Browns Ferry Nuclear Plant, Unit 2
Renewed Facility Operating License No. DPR-52
NRC Docket No. 50-260

Subject: **Response to Request for Additional Information Regarding Relief
Request 2-ISI-28 (TAC NO. ME8779)**

Response to Request for Additional Information Regarding Relief Request 2-ISI-28

DETAIL B
SCALE: 5"=1'-0"

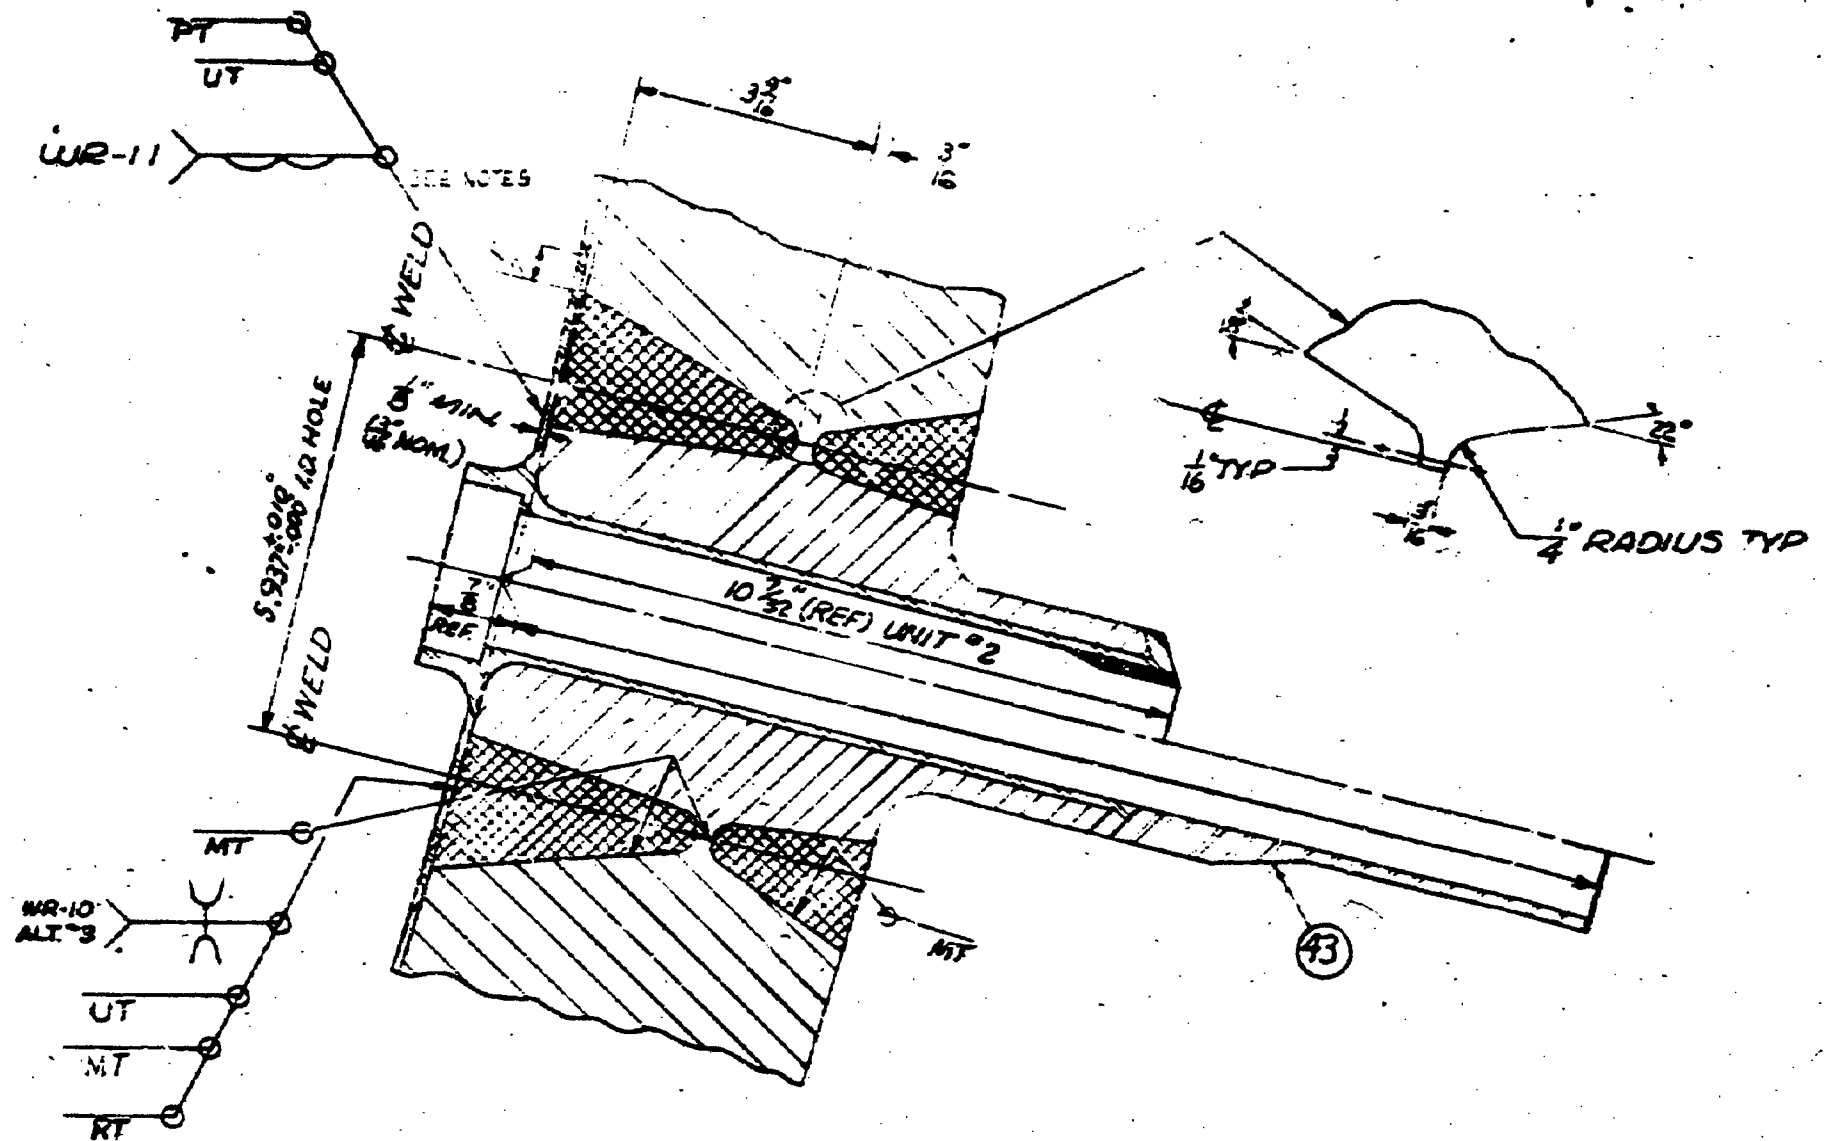
The Table on page E-6 indicates that the request is for two welds. For each sketch provided, identify the weld(s) that relief is being requested by using standard American Welding Society weld symbols pointing to each weld face to identify that weld. If a weld face contains more than one weld designation, identify this on each sketch

Request for Relief 2-ISI-28 requests relief from weld examination coverage requirements for one reactor pressure vessel nozzle-to-vessel full penetration weld and nozzle inside radius section. Attachment 1 shows the nozzle to vessel weld (N10-NV), including the requested weld symbols. A built up pad machined to form a socket for connection of Standby Liquid Control (SLC) piping is present on the inner radius of the nozzle forging. Details of the inner radius configuration are provided in Attachment 2.

Figure 4. Browns Ferry Standby Liquid Control Nozzle (N10): Probe Scan Limits and Examination Coverage for Vessel Shell Detection Technique, 70/(2 to 23)v.

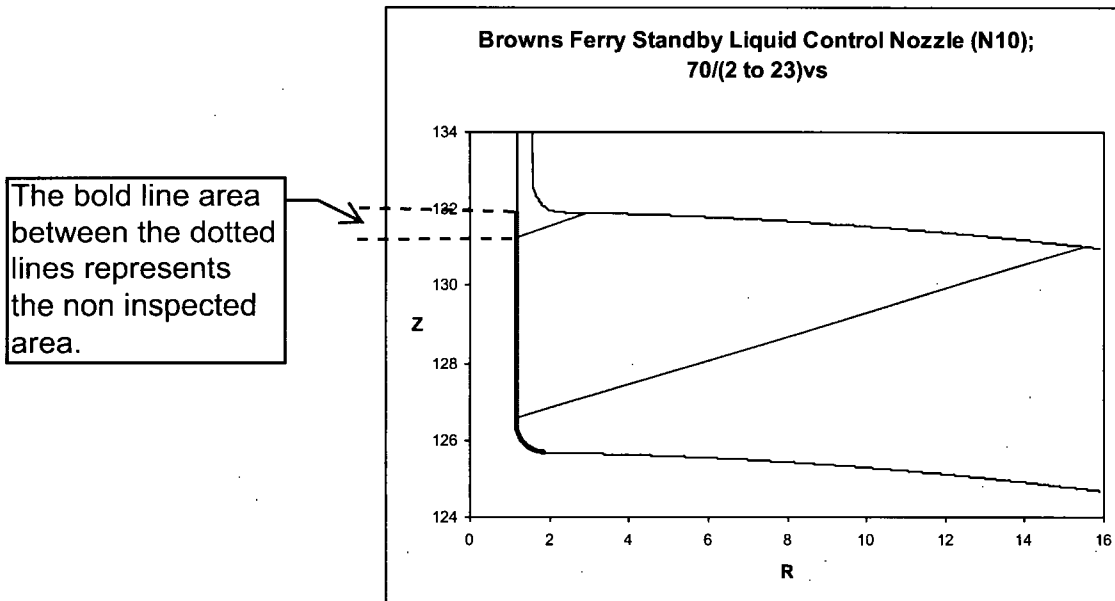
Address how the coverage for the N10-IR inner radius examination was calculated. Provide a coverage map showing the areas that were missed.

Modeling report IR-2004-43 was developed by the EPRI NDE Center. The essential geometric parameters of the Browns Ferry Standby Liquid Control nozzle and the qualified procedure essential variables were input into the EPRI software to calculate the coverage obtained. Attachment 3 provides the coverage map for the limited volume of coverage.

Figure 4 shows the minimum and maximum probe radial positions and the portion of the examination volume covered by the vessel shell detection technique, 70/(2 to 23)v, for probes scanned at the azimuth angle of 0°.
